## **Technical Service Information**

# SATURN NEW ACTUATORS FOR 1998

## 1997-1999 SATURN VALVE BODY

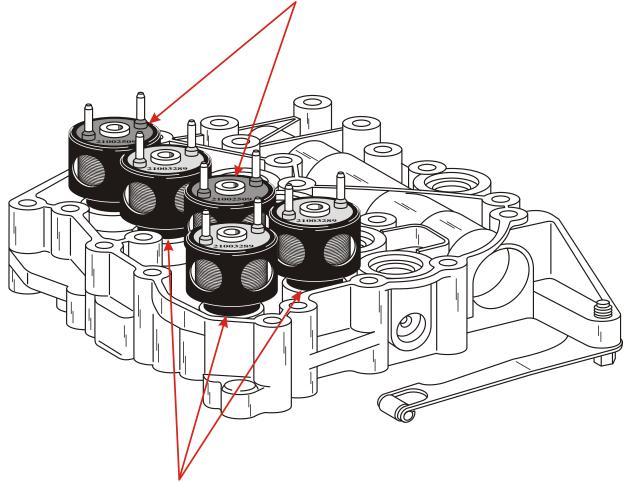
CHANGE: During the 1998 model year, a running change was made by Saturn to the control actuators used for the 2nd/Rev Clutch, the 3rd Clutch and the 4th Clutch. This change involves added screens on the new actuator, and now creates three different actuators depending on the model year that you are working on, as illustrated in Figure 1. 1st Design actuators, identified with the Black/Blue Tops are to be used in 1991-1992 model vehicles only. 2nd Design actuators identified with the Red Tops, are to be used in 1993-1996 model vehicles, and in 1997-1999 model vehicles in the Torque Converter Clutch (TCC) and Transaxle Fluid Pressure (TFP) positions only. The 3rd Design actuators identified with the White Tops, are to be used in 1997-1999 model vehicles in the 2nd/Rev Clutch, the 3rd Clutch and the 4th Clutch positions only in the valve body, as illustrated in Figure 2.

2nd Design control actuators (Red Tops) should be used in the Torque Converter Clutch (TCC) and the Transaxle Fluid Pressure (TFP) positions in the valve body as illustrated below.

3rd Design control actuators (White Tops) should be used "Only" in the 2nd/Reverse, 3rd and 4th Clutch positions in the valve body as illustrated.

3rd Design actuators (White Top) should be used only in the 2nd/Rev Clutch, 3rd Clutch and 4th Clutch positions in the valve body. Poor shifts may occur if the 3rd Design actuator is used in the TCC and/or TFP positions in the valve body (See Figure 2).
